**BELL BEND NUCLEAR POWER PLANT  
RESPONSE TO RAI NO. 115  
QUESTIONS 09.02.05-27, 09.02.05-29 and 09.02.05-32  
BNP-2013-020 Docket No. 52-039**

Response to RAI No. 115,  
Questions 09.02.05-27, 09.02.05-29-part 1, and 09.02.05-32-part 2

Figure 9.2-14— {Ultimate Heat Sink Systems}

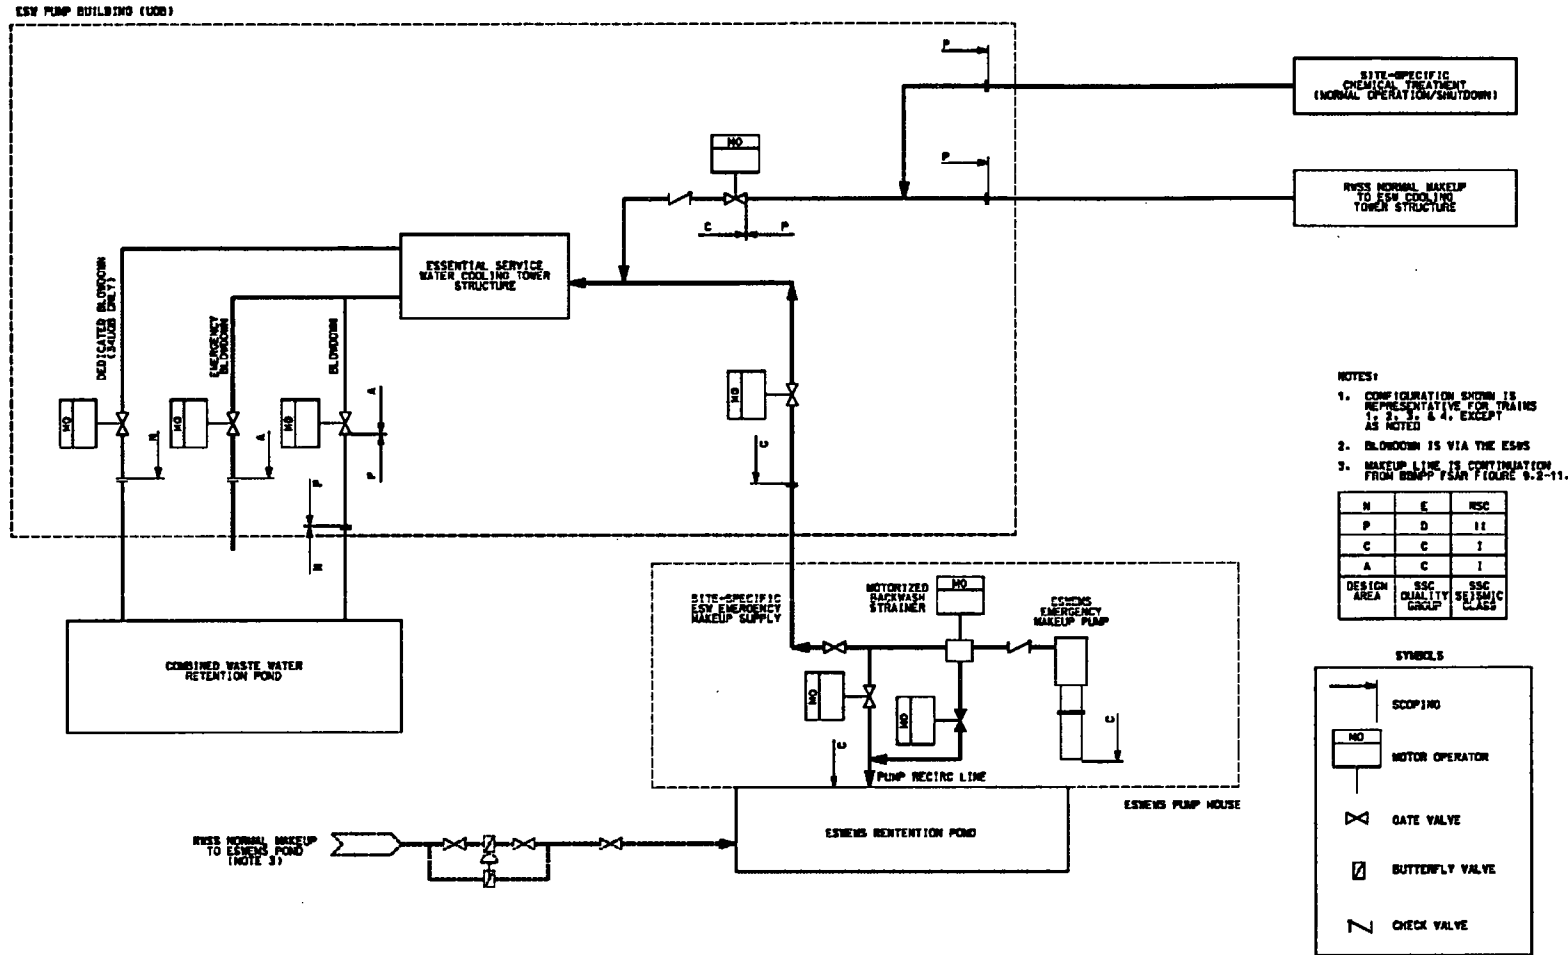
The staff reviewed RAI Letter 84 (RAI 3990) Question 09.02.05-5 part 2 response related to the chemical treatment and water quality related to the Essential Service Water Emergency Makeup System (ESWEMS) and finds that the applicant did not adequately describe the post accident chemical treatment philosophy because no description was added to the BBNPP FSAR. Specifically, the applicant should address in the FSAR:

- Details of the post-accident chemical addition to the ESWEMS.
- Details of the post-accident chemical addition to the ESWEMS related to GDC 2 and negative effects on SSCs important to safety.

The results of this evaluation for the UHS Cooling Tower Basin chemistry are shown in the below table for the three (3) to thirty (30) day post-DBA period. The procurement specifications for the ESWS equipment will specify that the components are to perform their safety related function given the chemistry conditions indicated in the table. Using this water chemistry will provide assurance that the ESWS system components can perform their design function during a 30 day period without chemical treatment. Therefore, no additional post-accident chemical treatment is required.

Consequently, BBNPP COLA FSAR Figure 9.2-14 will be revised to remove the ESWEMS Retention Pond site-specific chemical treatment system. Additionally, FSAR Table 14.3-3 will be revised to indicate an ITAAC is not required since post-accident chemical treatment is not required. This response supersedes the information regarding post-accident chemical treatment system provided in the last paragraph of the PPL response<sup>1</sup> to Bell Bend RAI No. 84 Question 09.02.05-5 part 2.

BBNPP COLA FSAR Section 9.2.5.2.4, Figure 9.2-14 and Table 14.3-3 will be revised in a future revision of the COLA as shown below:
